APPLICATION NO.	FILING DATE	FIRST NAMED INVENTOR	ATTORNEY DOCKET NO.	CONFIRMATION NO.
10/774,963	02/09/2004	Keith Edward James Blodgett	GE143949	4224

## Office Action Summary

This is the first office action in response to the above identified patent application filed on 02/09/2004.

FIG. 3

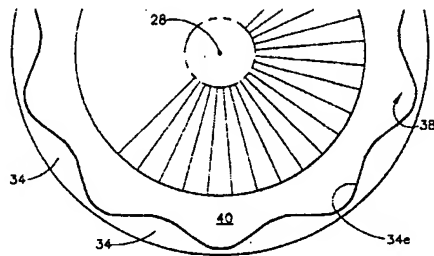
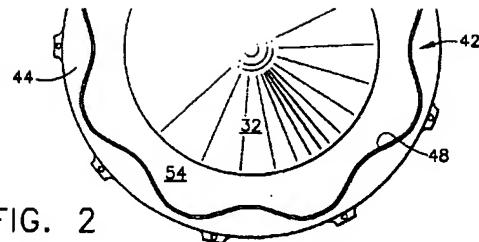
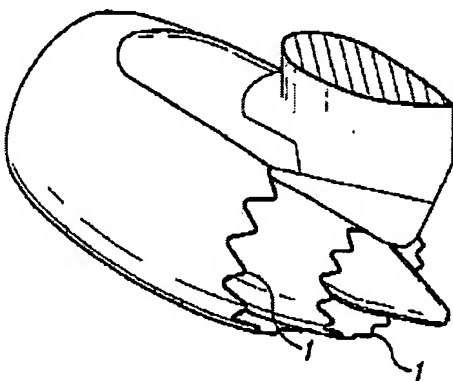
3. Claims 1-26 are rejected under 35 U.S.C. 102(b) as being anticipated by Martens (US 2002/0178711).

Martens (particularly figures 1-4) teaches a gas turbine engine comprising: a core engine exhaust nozzle, a fan exhaust nozzle and a center plug, wherein both nozzles have chevrons extending from an aft end of said exhaust nozzles, said chevrons having a radially inner surface and outer surface bounded by a laterally sinuous trailing edge, said chevrons having a sinusoidal shape.

*Fig. 1*

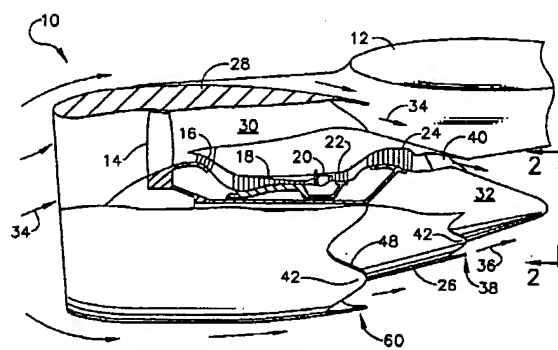
4. Claims 1-26 are rejected under 35 U.S.C. 102(b) as being anticipated by Balzer (US 2001/0035004).

Balzer (particularly figures 1-2, 4) teaches a gas turbine engine comprising: a core engine exhaust nozzle, a fan exhaust nozzle and a center plug, wherein both nozzles have chevrons extending from an aft end of said exhaust nozzles, said chevrons having a radially inner surface and outer surface bounded by a laterally sinuous trailing edge, said chevrons having a sinusoidal shape.
